Colace Rome Parking Lot  
Franklin, MA

**PHOTOMETRIC PLAN**  
PROPOSED PARKING LOT  
19 Cottage Street  
FOR  
James A. Colace/Abbruzzi Realty Trust  
55 Court Street  
Franklin, MA 02038

DATE: March 15, 2024  
DRAWN BY: S. Dunbar  
PLAN NO: 24-04

PHOTOMETRIC PLAN  
NTS

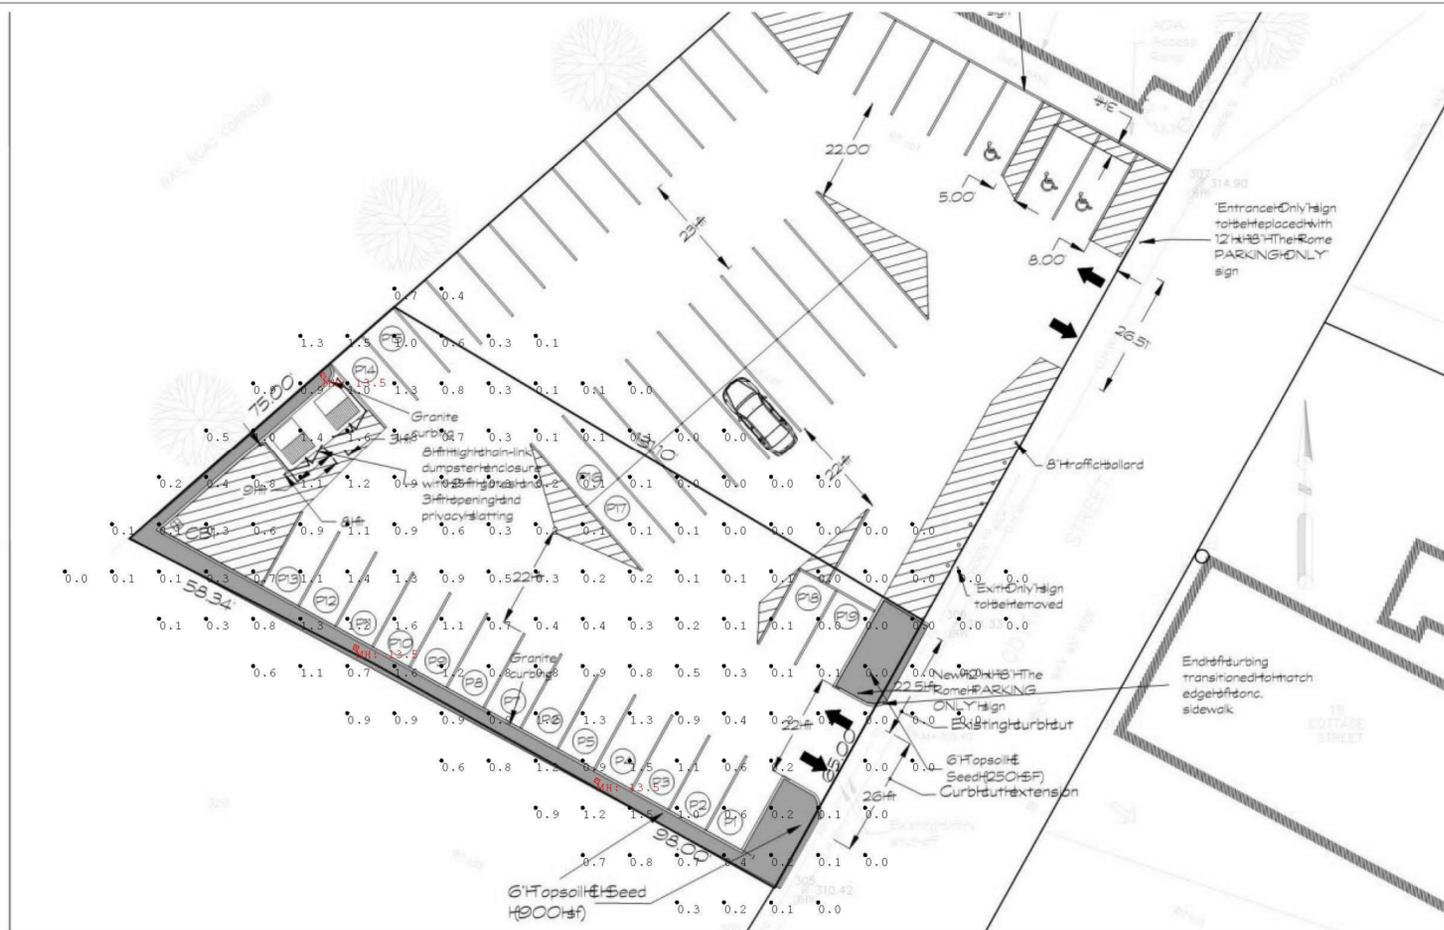
REVISIONS		
2	9/12/24	Light fixture changed to Amerlux D771 (almost identical photometric plan).
1	5/9/24	New plg layout Lots 217 & 17; Luminaire height changed to 13.5 ft.
